Re: FortisBC Energy Inc. (FEI)

**Application for a Certificate of Public Convenience and Necessity (CPCN) for the
Tilbury Liquefied Natural Gas Storage Expansion (TLSE) Project (Application)**

**Response to the British Columbia Public Interest Advocacy Centre representing
the British Columbia Old Age Pensioners' Organization, Active Support Against
Poverty, Disability Alliance BC, Council of Senior Citizens' Organizations of BC,
and the Tenant Resource and Advisory Centre *et al.* (BCOAPO) Information
Request (IR) No. 6**

Figure 1: Transportation Service Customer Winter Load Duration Curve (2016/2017 to 2024/2025)

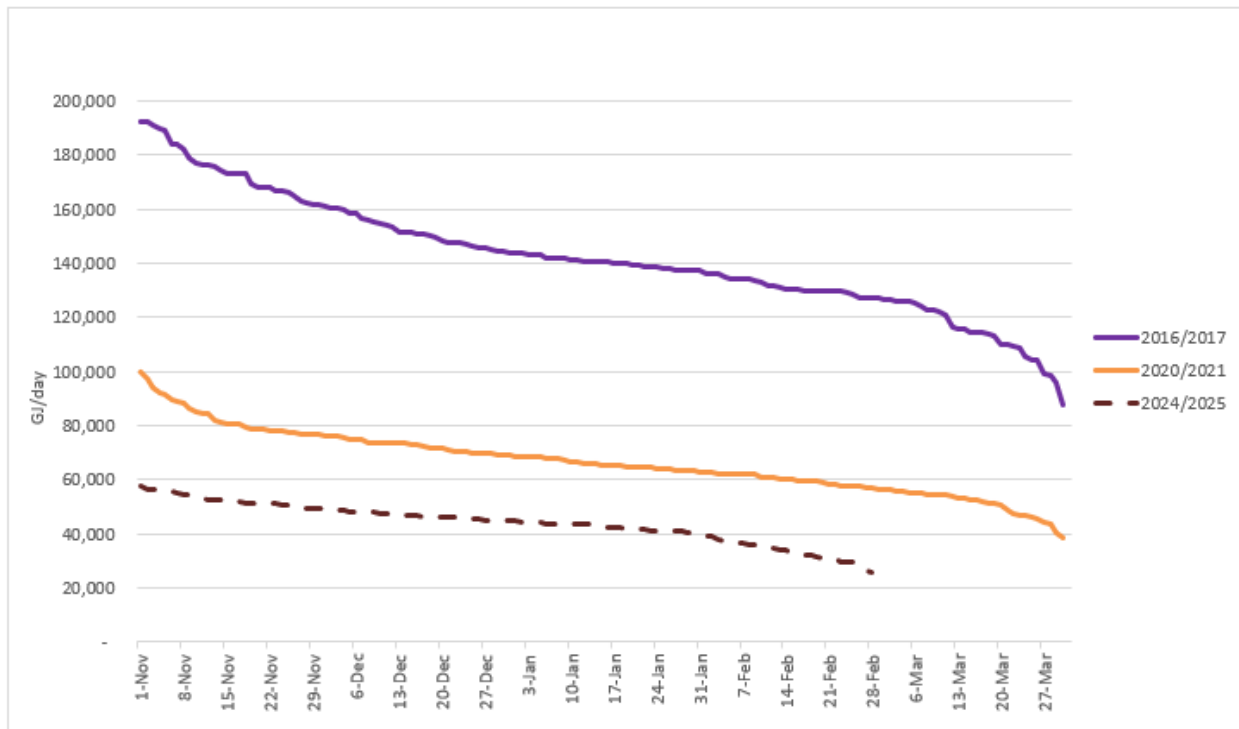
Response:

FEI expects that the Transportation Service customers in the Lower Mainland will continue to move back to the bundled service, given the risk of frequent and sustained pricing events during high demand periods will likely persist until there is some relief in the way of incremental pipeline capacity. However, there are only approximately 375 customers left on the Transportation Service model and the load associated with these customers is minor compared to what it was back in 2016, as the figure below illustrates.

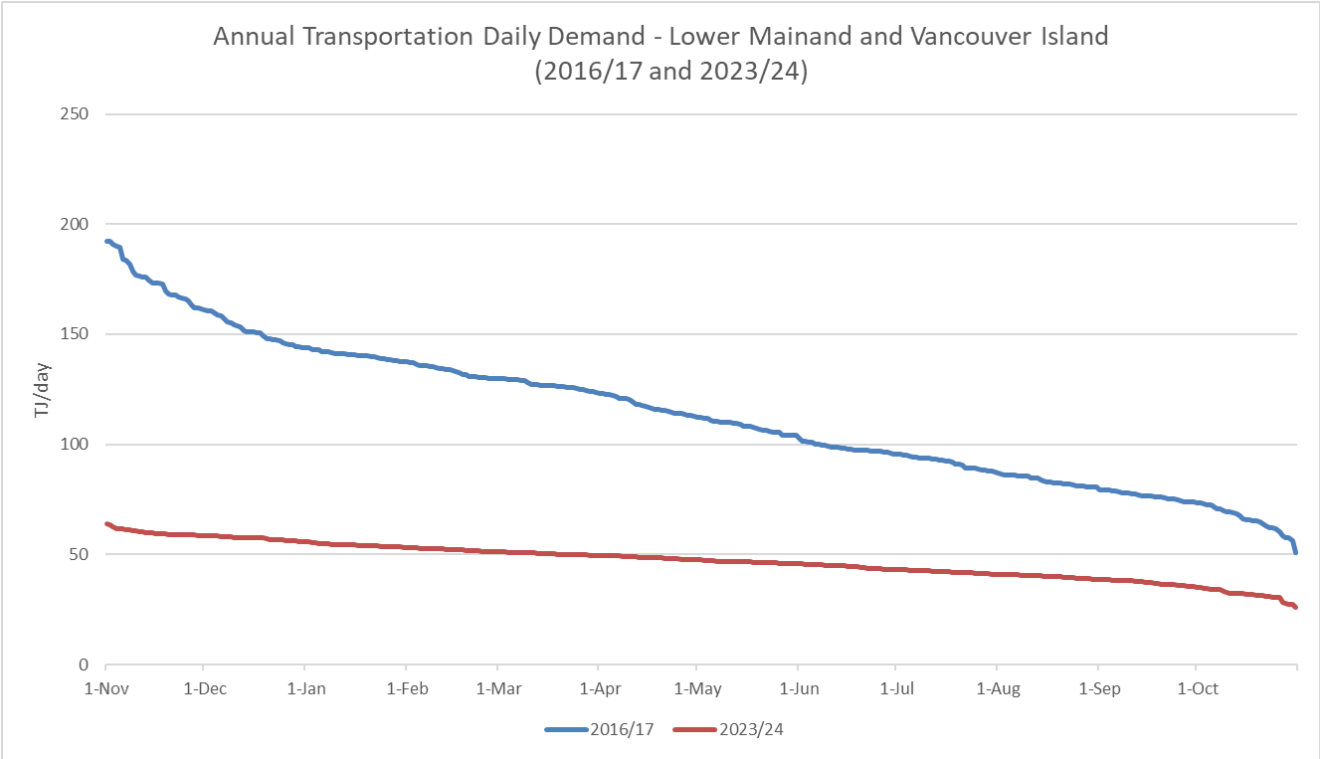
1
2 4.4 Please provide a version of Figure 1 (BCUC IR 5 – 118.1) that excludes or
3 otherwise nullifies the increase in annual design load and peak day demand
4 associated with Transportation customers returning to Core customers. As part of
5 the response, please provide the increase or decrease in both the annual design
6 load and peak day demand and discuss what (and who) is driving the change (in
7 the absence of the impact associated with Transportation customers).
8

10 The load forecast used for FEI's gas supply planning is developed by studying the historical
11 consumption of Core customers (RS 1 to 7 and 46) as a single group. FEI does not separate the
12 forecast by customer group and, therefore, cannot provide a version of Figure 1 from the response
13 to BCUC IR5 118.1 that excludes the Transportation Service customers. The increase of annual
14 and peak demand due to Transportation Service customers returning to the bundled Sales service
15 is embedded in the load forecast in addition to the organic growth due to the customer additions
16 FEI has experienced in the past.

Revised Figure 4-9 from FEI's 2022 LTGRP Application with Hypothetical mDEP 2% and mDEP 5% Added

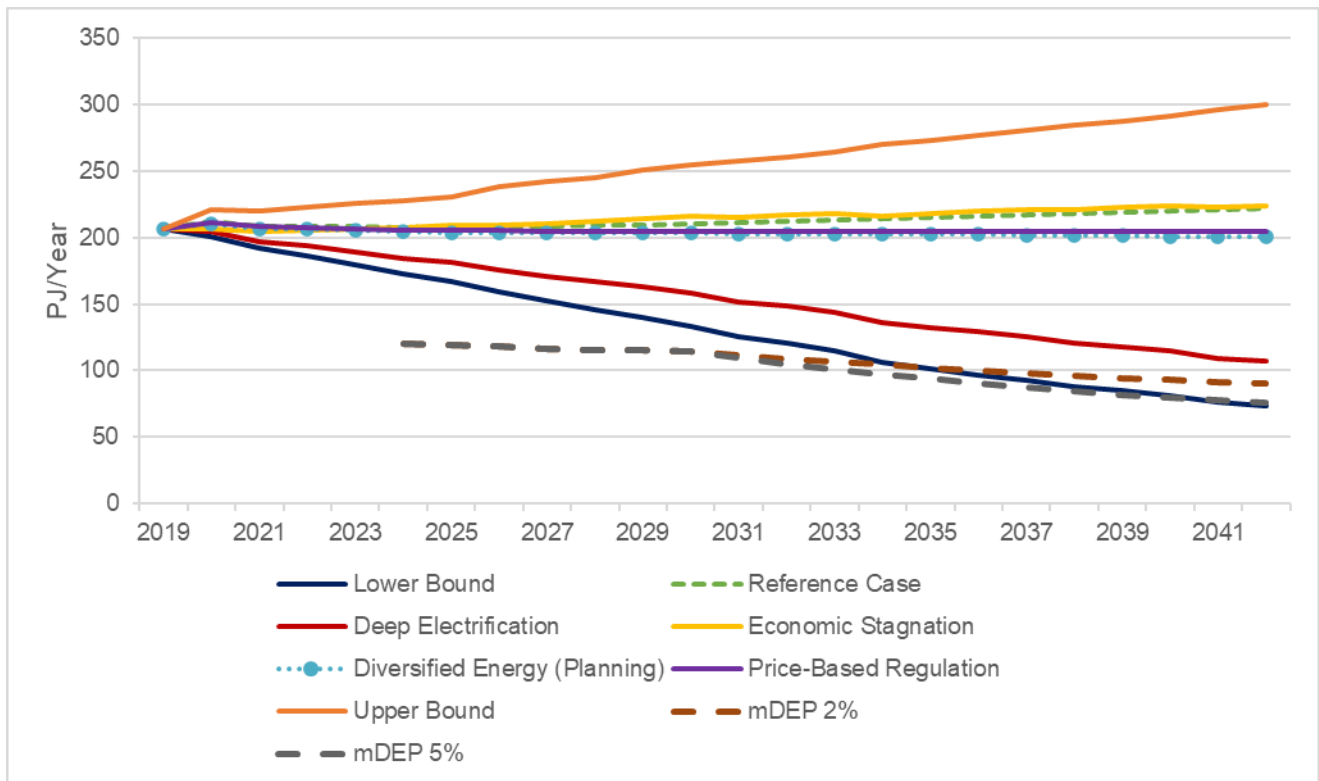
10
11
12
13 5.2 Please provide, with discussion, a version of Figure 4-9 filed as part of the FEI
14 2022 LTGRP (Exhibit B-1 p. 4-28) and replicated in BCUC IR 5 – 118.0 that
15 incorporates the mDEP 2% and 5% scenarios.
16

18 Figure 4-9 from the 2022 LTGRP includes annual demand scenarios for all of FEI’s residential,
19 commercial and industrial customers, which includes Rates Schedules 1, 2, 3, 4, 5, 6, 7, 22, 23,
20 25 and 27. As discussed in the Supplemental Evidence, FEI began with the same Diversified
21 Energy Planning (DEP) Scenario that was used to create Figure 4-9 in the 2022 LTGRP, and then
22 modified the analysis to reflect which rate schedules, region and number of customers the TLSE
23 Project would serve as a resiliency asset.¹⁰ These modifications resulted in a different starting
24 point for the graphed demand lines shown in the figure below. Otherwise, the primary difference
25 in the starting year of 2024 between the mDEP scenarios and the DEP annual demand scenario
26 from Figure 4-9 is the exclusion of non-Core rate schedules in the analysis presented in the
27 Supplemental Evidence.

As shown in the figure above, the mDEP hypothetical scenarios start at approximately 84 PJ lower than the DEP Scenario due to the removal of non-Core rate schedules and the narrower region of the Lower Mainland compared to FEI's entire service area. The trajectory then follows the DEP Scenario until 2031, when customers and load start to be eliminated from the mDEP scenarios. In 2042, mDEP 2% is 110 PJ lower than the DEP Scenario and mDEP 5% is 125 PJ lower than the DEP Scenario. As a result, if the hypothetical loss of customers and load were to occur, FEI estimates that its load would be 26 to 41 PJ lower than the DEP Scenario.

Figure 1: LNG Reserve Needed (Current vs mDEP 2%) in 2050

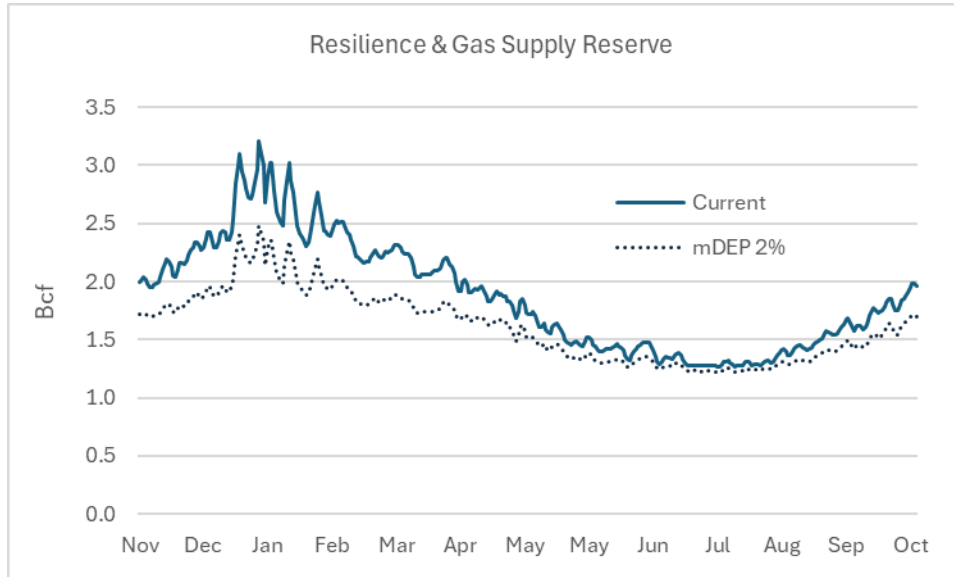
5.4 Further to BCOAPO IR 6.5.3 above, please provide a table that: i) identifies the peak and annual load assumed in the TLSE Project; ii) identifies the peak and annual load based on the mDEP 2% sensitivity in 2050; iii) identifies the difference (PJ and %) between the TLSE Project and the mDEP 2% sensitivity in 2050; iv) identifies the difference between the TLSE Project (with load assumptions underpinning the 3-day no-flow T-south event) compared to the mDEP 2% scenario in 2050 (please provide the difference in \$ and % along with the present value of the incremental cost); and v) the TLSE alternative today, if any, that most closely meets the mDEP% 2% scenario in 2050.

The Supplemental Evidence supports the need for a 2 Bcf resiliency reserve and 1 Bcf as a gas supply peaking resource. Based on the assumption that customers, and their associated peak day demand, decreases at 2 percent or 5 percent per year, the 3-day cumulative demand calculated for these two hypothetical scenarios are shown below in Figures 1 and 2, respectively. FEI notes the analysis assumes the same LNG reserve (1 Bcf) is needed for gas supply to meet peak demand.

Figures 1 and 2 above show that FEI would still need approximately 2 to 2.5 Bcf for resiliency and gas supply purposes even under extremely adverse hypothetical load scenarios. However, as discussed in Section 4.5.5.4 of the Supplemental Evidence, even if less reserve were needed for resiliency due to a load decrease in the future, FEI could reallocate part of the resiliency reserve to gas supply, substituting LNG for other resources or generating mitigation revenue by making peaking supply available in the market. For example, with the additional LNG allocated to the gas supply portfolio, FEI would be able to de-contract some market area resources FEI currently holds and reduce the gas supply costs accordingly, ultimately benefiting customers through reduced cost of gas charges.
